August 11, 1987

I have recently reviewed the connector drawings that AMP supplied for inclusion in the ESDI (See Attachment #1), and wish to make some constructive comments. My comments are based on the assumption that flat ribbon cable will be utilized, although I was unable to find cable descriptions in the present document.

P1 CARD EDGE CONNECTOR DIMENSIONS

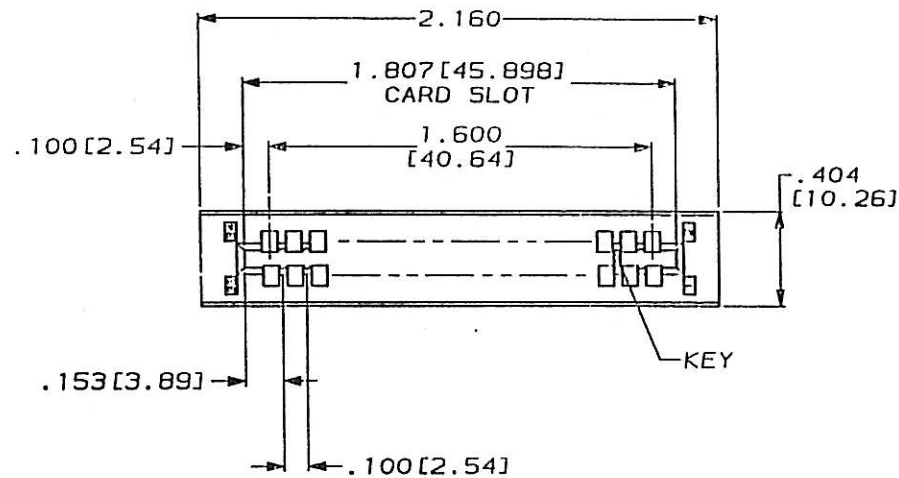
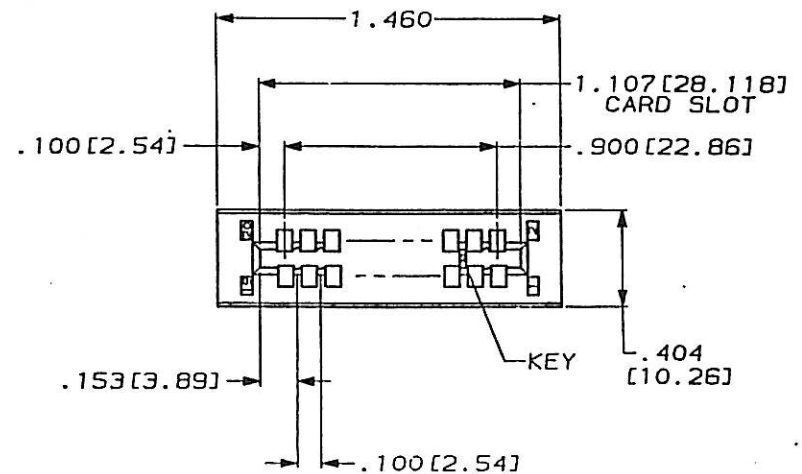
I do not have a problem with the card edge connectors depicted provided that the width specified (.404") be made a reference dimension.

J1 PCB HEADER CONNECTOR DIMENSIONS
METRIC DIMENSIONS ARE IN PARENTHESIS

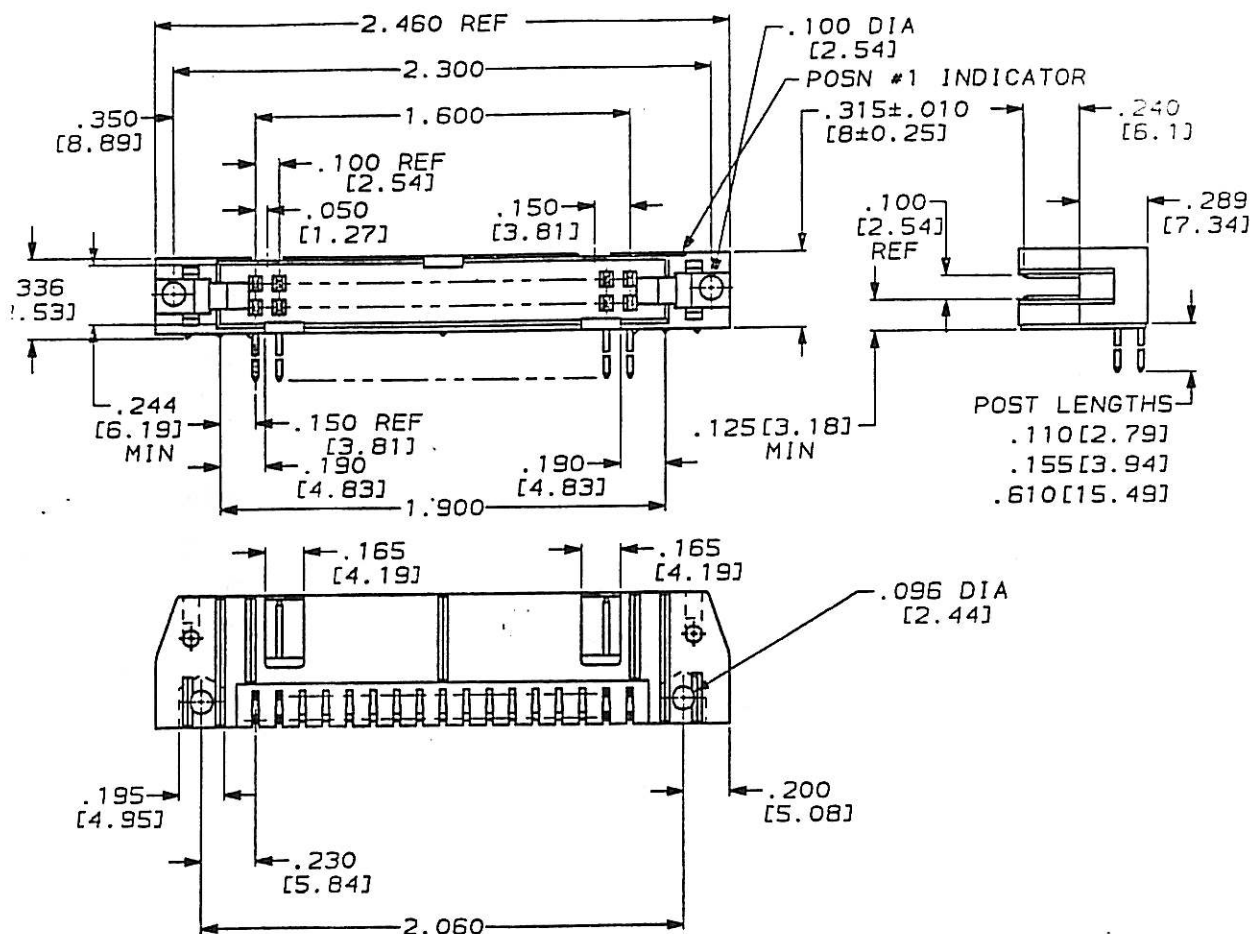
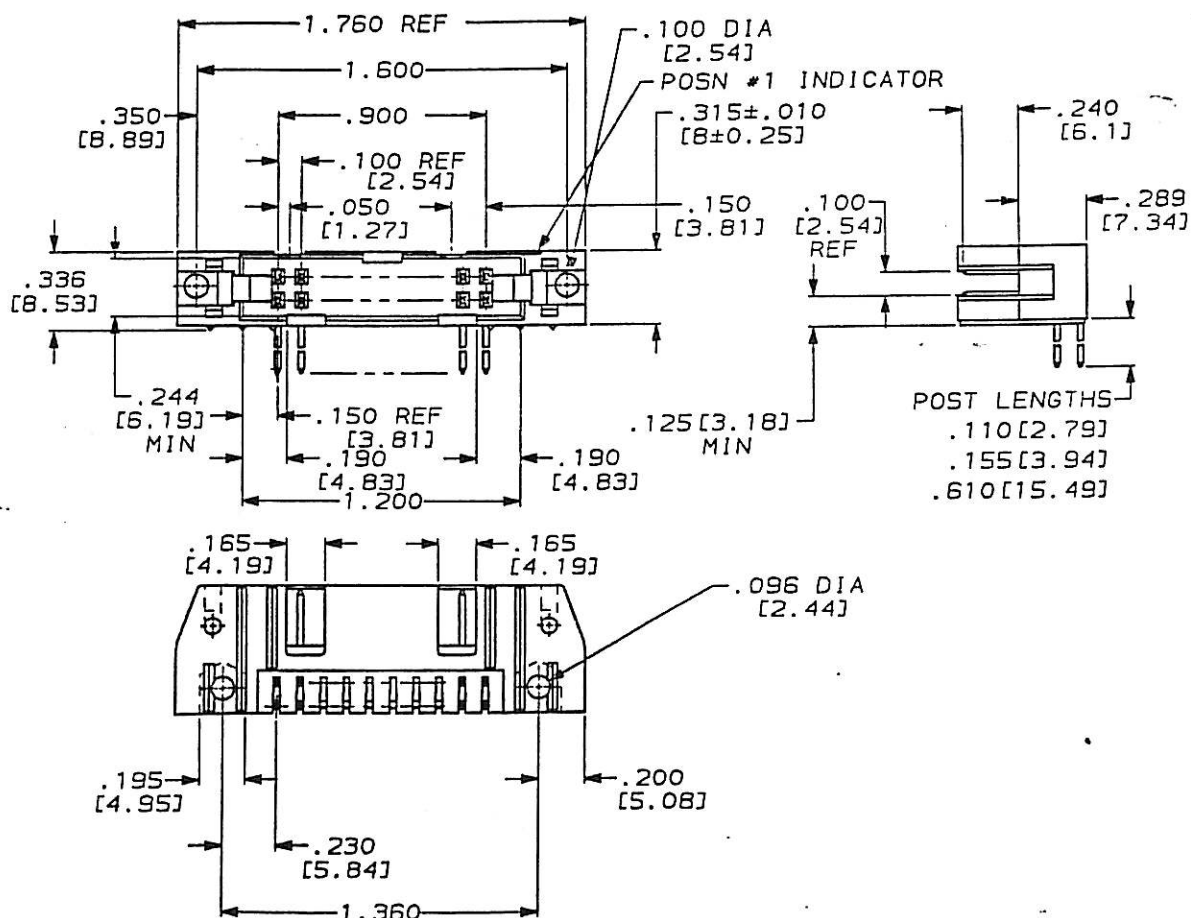
Besides having a great deal of information on the diameter of mounting holes, and the length of solder tails, the 20 pin and 34 pin headers and receptacles (J1/P1 and J2/P2) are depicted as having two polarization bars. I question whether this is really a necessity on these parts. By far the most prevalent polarization feature is a single center bar. Use of the two bar configuration may very well limit the user to a single source of supply.

I recommend that instead of using these connectors, the center polarized non-shielded connectors accepted in the SCSI document (X3.131-1986 p.18 & 19) be adopted with downsizing. These configurations were accepted by all member connector manufacturers, and offer the user multiple sources of supply. I have taken the liberty of modifying these drawings, and show them as attachments #2 and #3.
